### STATE OF NORTH CAROLINA DEPARTMENT OF TRANSPORTATION

### Addendum No. 3

RE: Contract # C204739 WBS # 32572.3.14 FEDERAL-AID NO. 0129008 Graham County (A-0009CB) NC 143 FROM SR 1223 (BEECH CREEK ROAD) TO 0.5 MILES NORTH OF APPALACHIAN TRAIL.

SHEET 1 OF 6

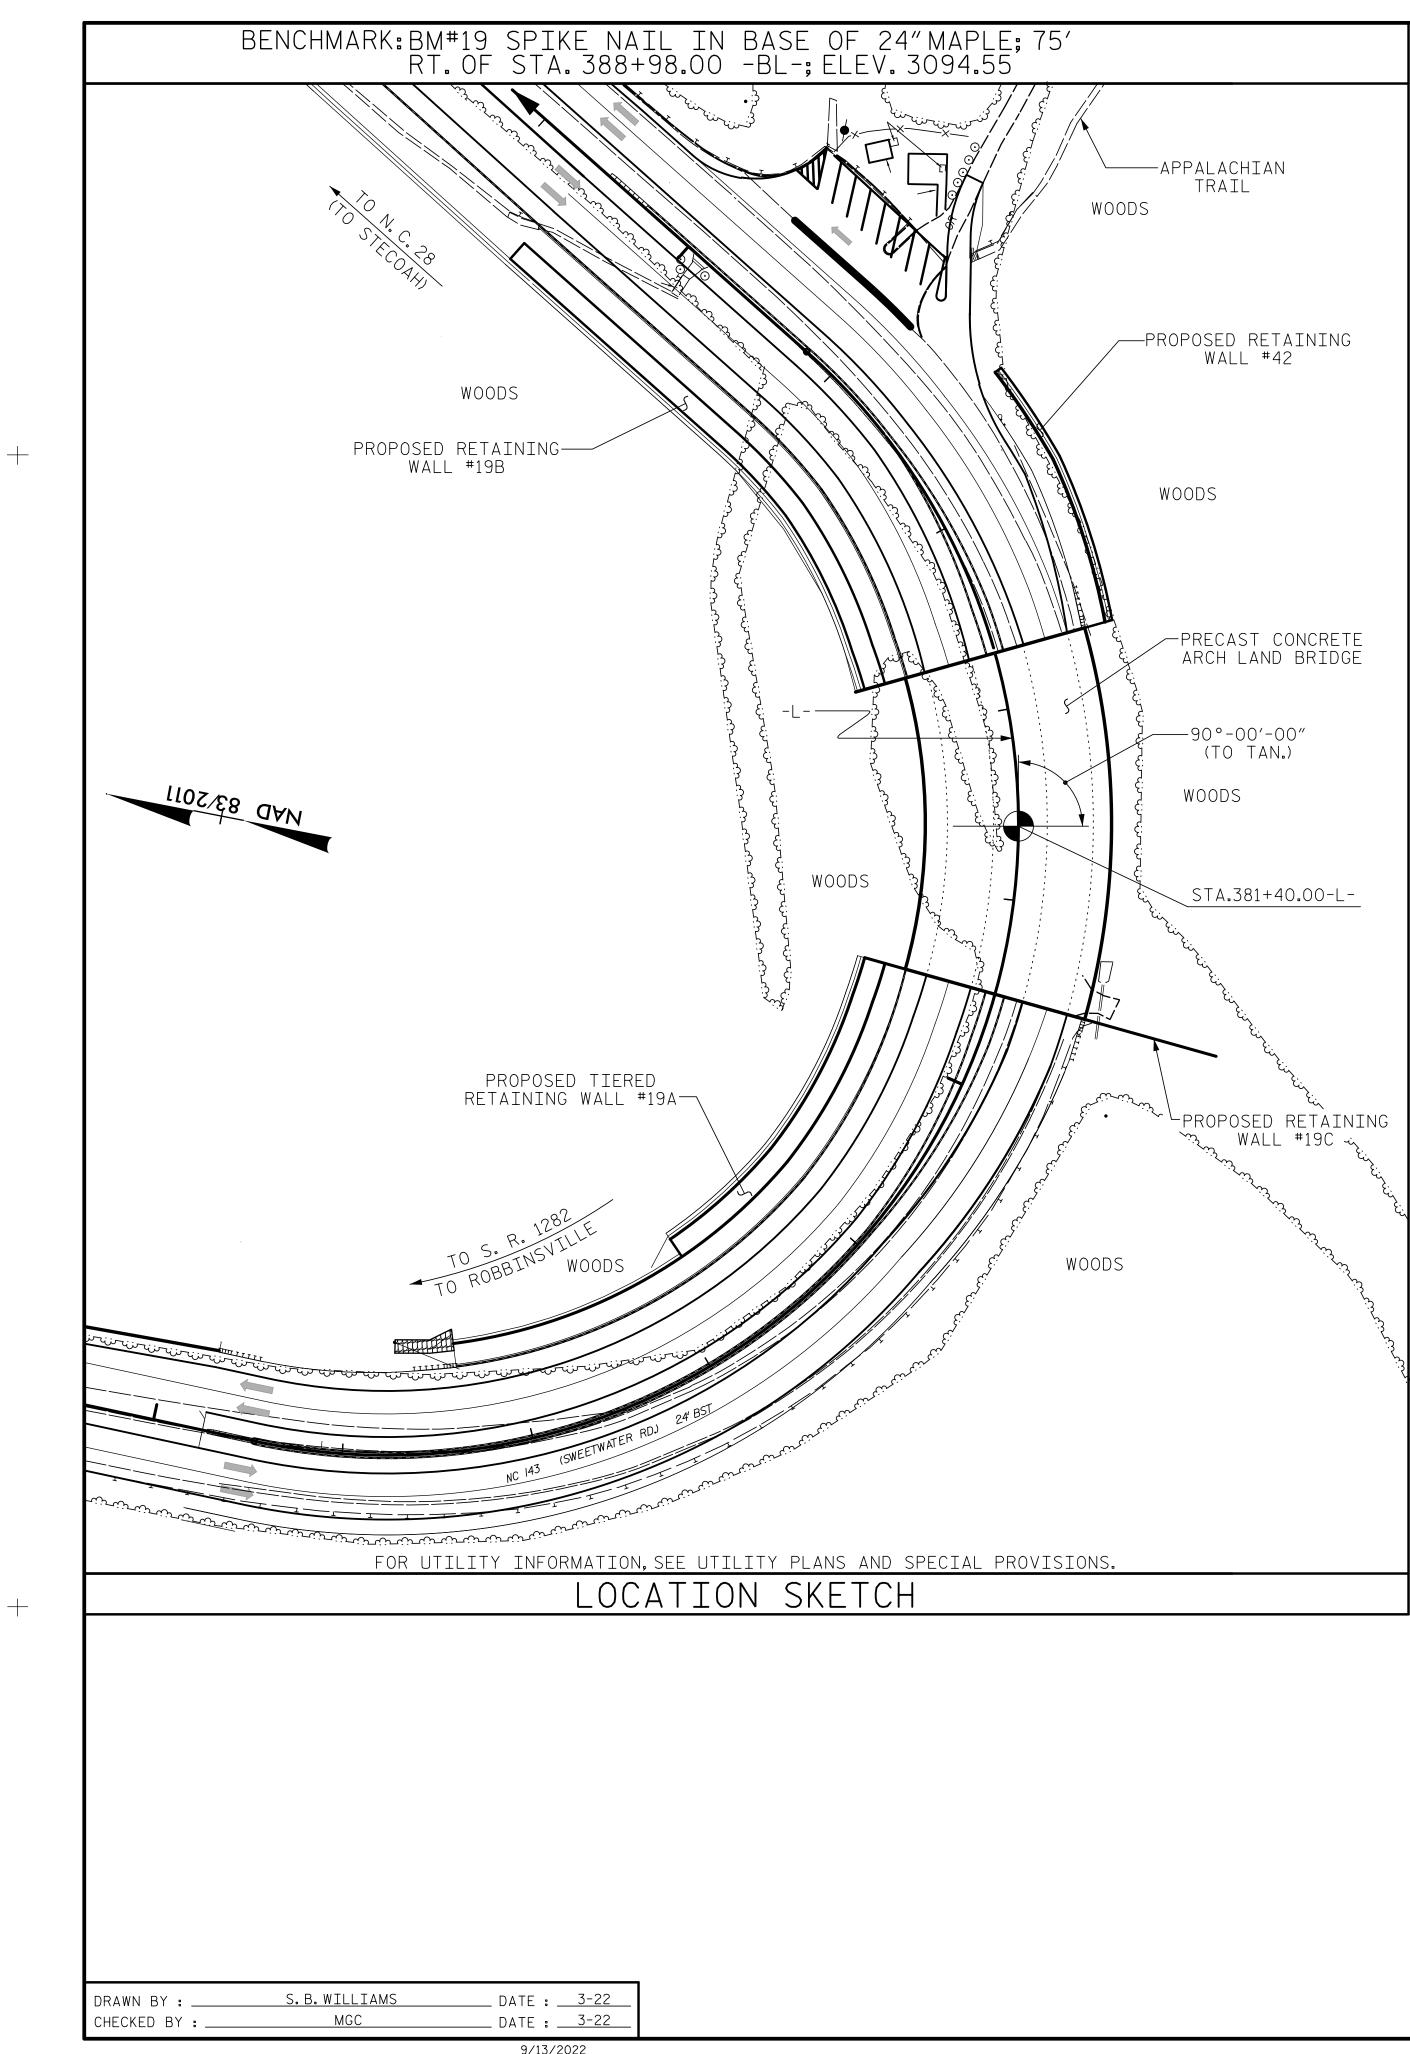
Sheet No.	Revision
S-1	Added Note: All Precast Concrete Arch Units shall be
	installed in place before any fill can be placed on the units.
S-3	Added a minimum 6" dimension from the top of parapet to the proposed fill.

ALL PRECAST CONCRETE ARCH UNITS SHALL BE INSTALLED IN PLACE BEFORE ANY FILL CAN BE PLACED ON THE UNITS.
